Office Action Summary

10/694,772

DETAILED ACTION

attachment # 1
(06 07/08/05)

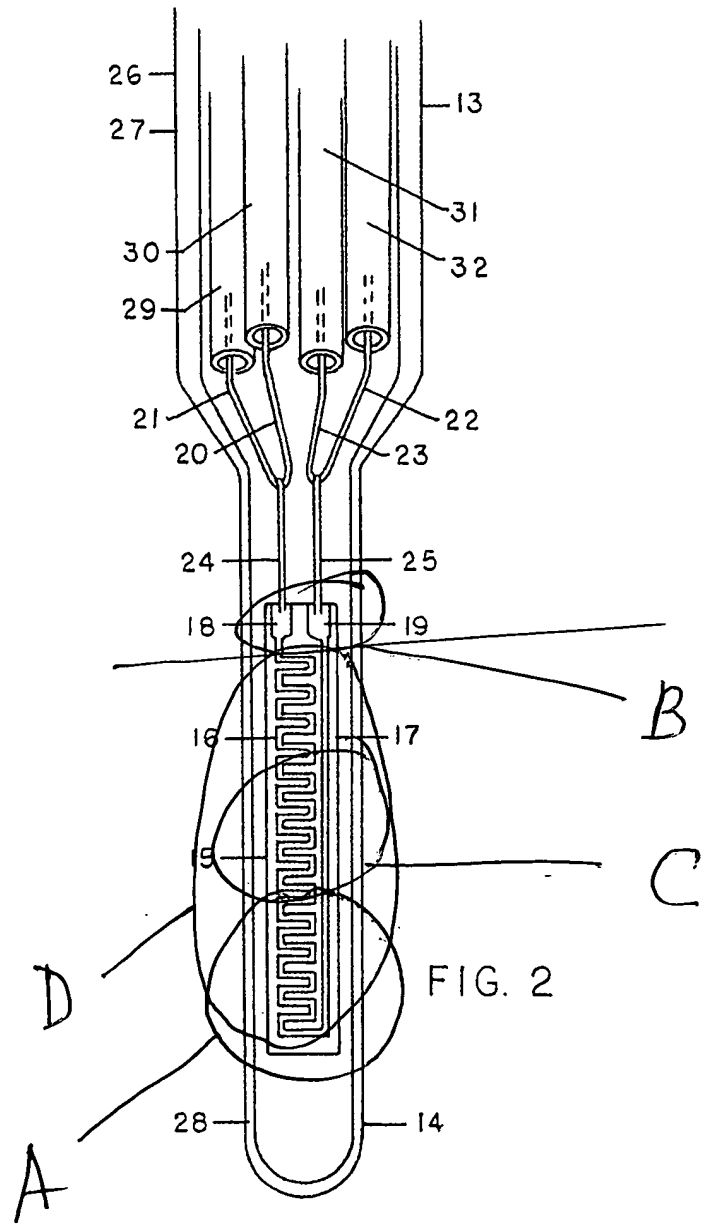
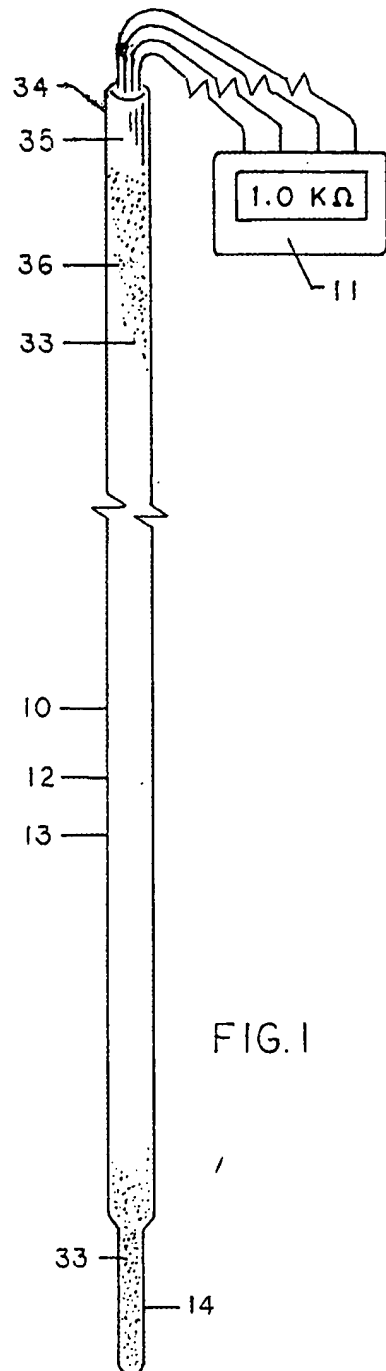
Schermund discloses in Fig. 2 a device comprising a base insulating substrate/board having a conductive layer comprising a temperature detecting portion formed as a wiring made of a thin film platinum/ metal foil) 16 formed in a serpentine pattern (wiring folded in such continuous form that adjacent parts of the wiring parallel are spaced apart from each other at a predetermined interval), as shown in Fig. 2. The

portion 16, inherently, changes its resistivity (specific resistance) proportionally to a temperature change. As shown in Fig. 2, the conductor layer formed entirely to the base insulating layer in a predetermined (desired) pattern, wherein the base insulating layer has a generally rectangular flat strip shape (thin) with generally rectangular widened end portions A, B and a central portion C. The conductive layer, inherently, changes its resistance (specific) proportional to a temperature change.

The base insulating layer is formed on to one side (under one side) of the conductor layer. The temperature-detecting portion D is formed on the top of the base insulating layer at the generally rectangular flat widened portion A. (The numerals A-D have been added by the examiner, see attachment # 1 to the Office action).

(attachment #2)
06 07/08/05

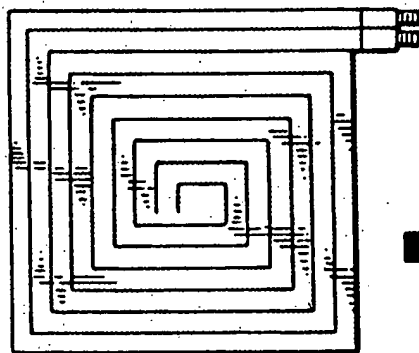
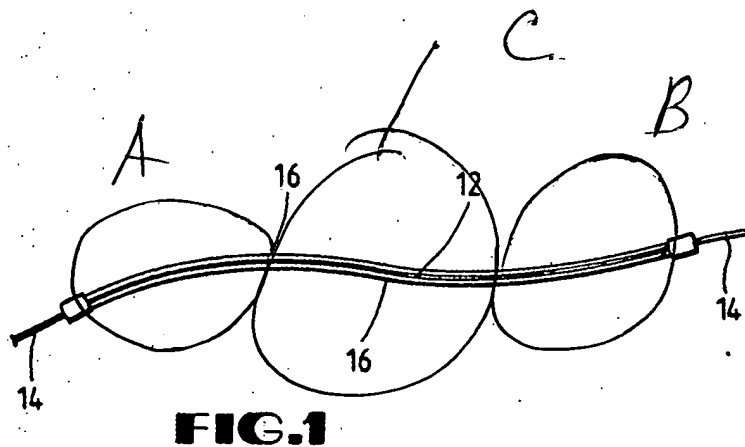
Kiec discloses in Figs. 1 and 6B a flexible wired board/ device/ RTD comprising a base insulating layer/ barrier 16, a cover insulating layer/ barrier 16, a conductor layer comprising a resistive pattern/ metal foil/ film (temperature measuring sensor-wiring) 12 formed onto the base insulating layer 16 and covered with the cover insulating layer 16, and a main wiring (leads) 14. The resistive pattern 12 can be a serpentine shape, as shown in Fig. 6B, or any desired shape (col. 10, lines 1-12). Kiec states that any metal could serve as the resistive pattern 12 of the conductor (col. 5, lines 49-50). The base insulating layer has a generally rectangular flat strip shape (thin) with generally rectangular widened end portions A, B and a widened central portion C. The temperature measuring sensor wiring, as shown in Fig. 1, is positioned on the base insulating layer at its widened flat end portions and at its widened flat central portion. (The numerals A-C have been added by the Examiner, see attachment # 2 to the Office action).

Attachment # 3
(07/08/05)

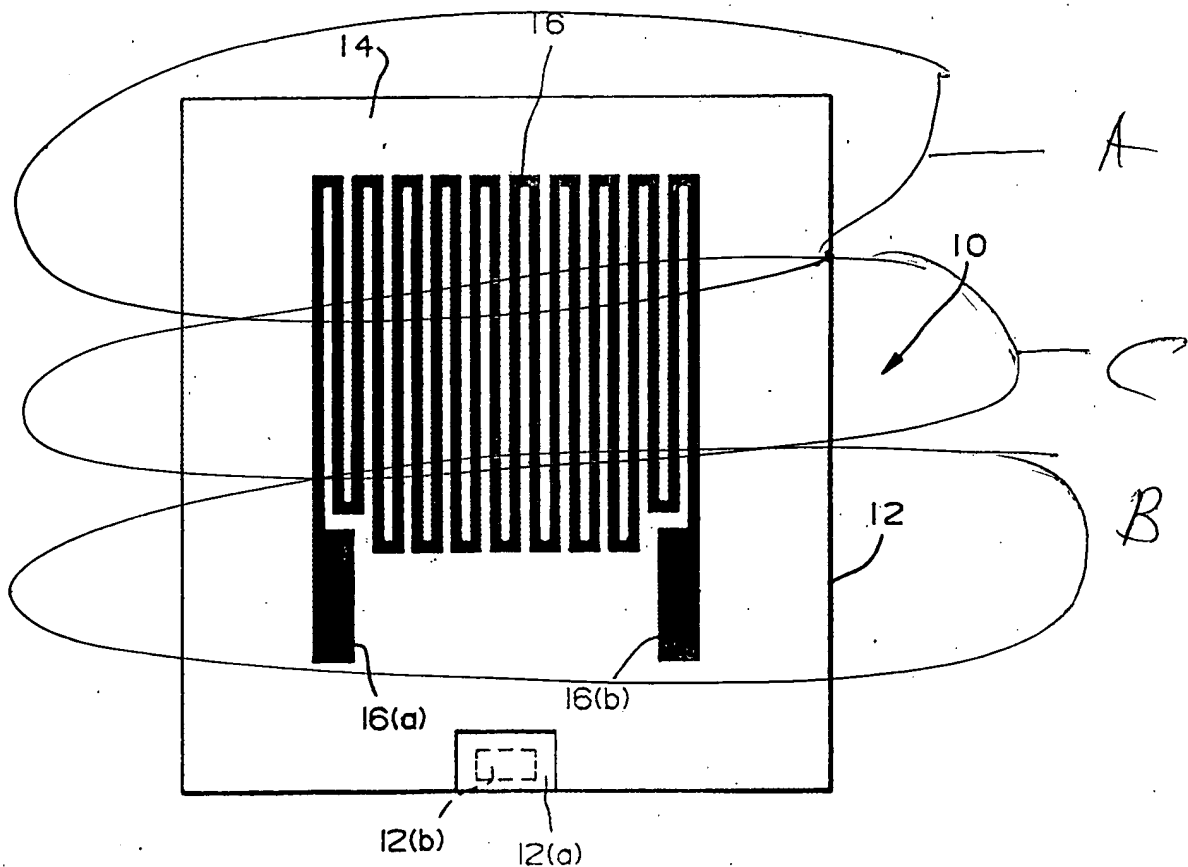
Schultz discloses in Fig. 2 a device/ circuit board for measuring temperature.

The device comprises a conductor layer (metal foil) 16 formed in a serpentine shape (continuous shape, as claimed by applicant) and comprising a temperature measuring wiring 16 and a main wiring 16a and 16b. The temperature sensing wiring 16 is substantially positioned on one end portion A of a generally rectangular base insulating layer 14 attached one side (bottom side) the conductor. The main wiring 16a and 16b is positioned on the another end portion B of the base insulating layer, wherein, the base insulating layer comprising flat widened end portions A and B and a flat widened central portion C (the numerals A-C have been added by the examiner, see attachment # 3 to the Office action).
